ARCHITECT'S SUPPLEMENTAL INSTRUCTIONS

JONES GILLAM RENZ DOCUMENT JGR 710

PROJECT: The Reserves at Cobalt Circle Report No. Three (3)

New Development Brownsville, TN

DRAWING NO. S003

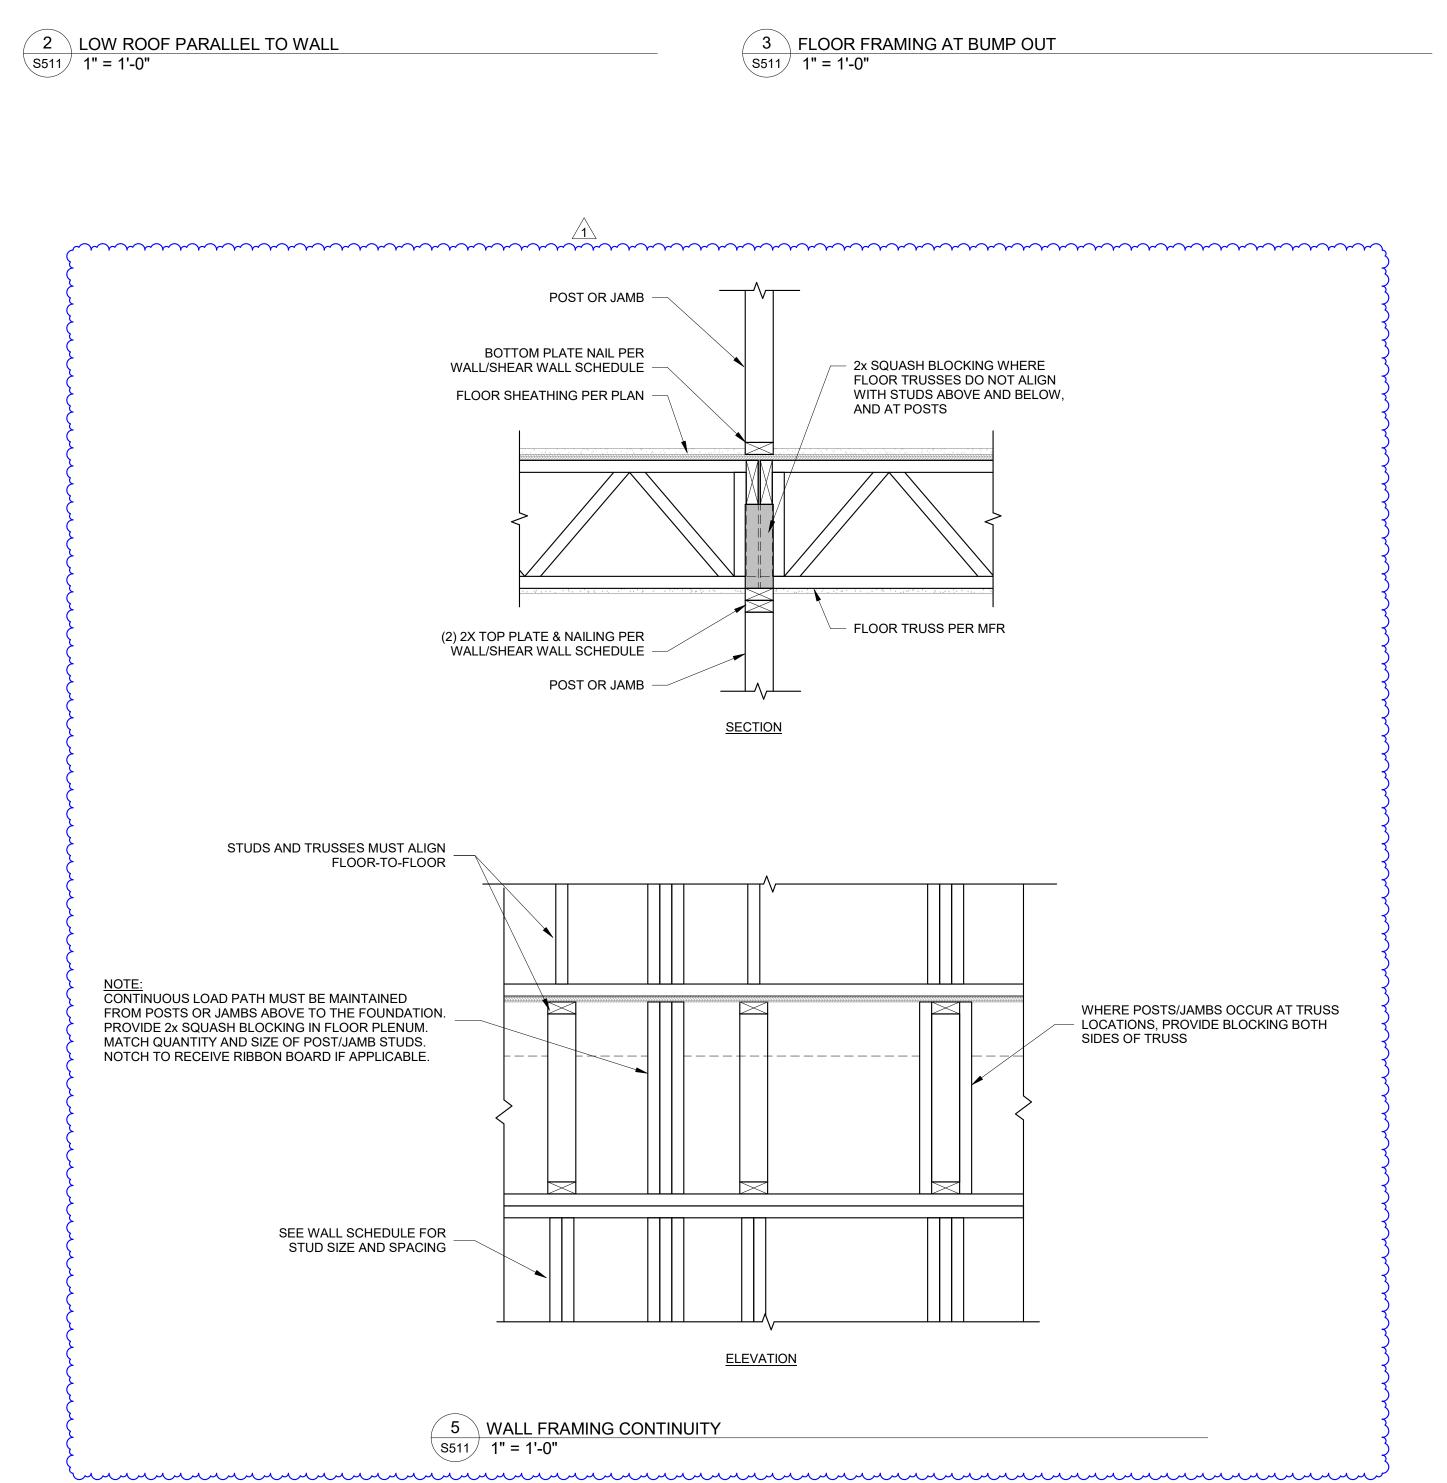
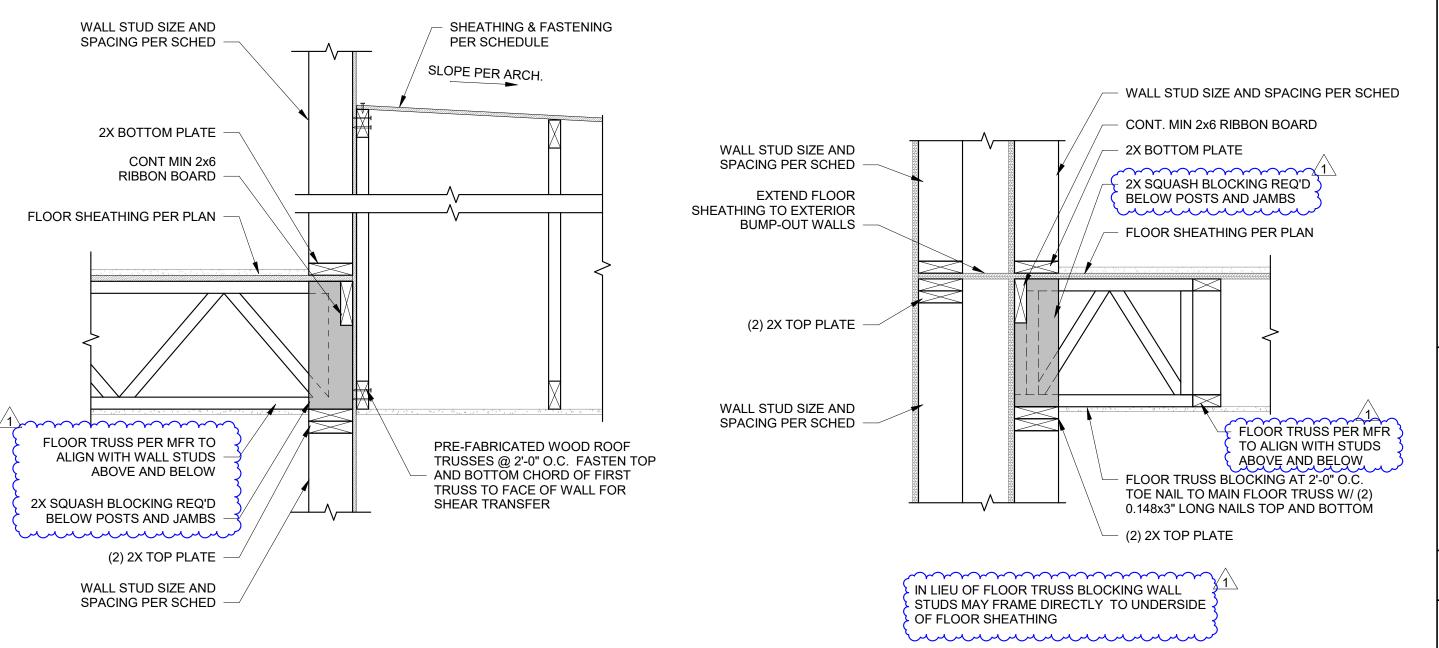
- Civil Revisions
 - Replaced the two sanitary sewer trunk lines serving Buildings B and C with a single line.
 - Modified the location and invert elevation of cleanouts for all buildings.
 - Relocated SMH #6 to be perpendicular to the trunk line coming out of Building C C.
 - Revised the rim elevation, pipe length and slope for SMH#6 d.
 - Updated the S.S. Plan & Profile, Sanitary Sewer Plan and Utility Plan to reflect these changes.
- Stud spacing has been revised reference revised sheets S003 and S511
- Revised Sheet P1.1 has been revised to reflect Civil changes made.
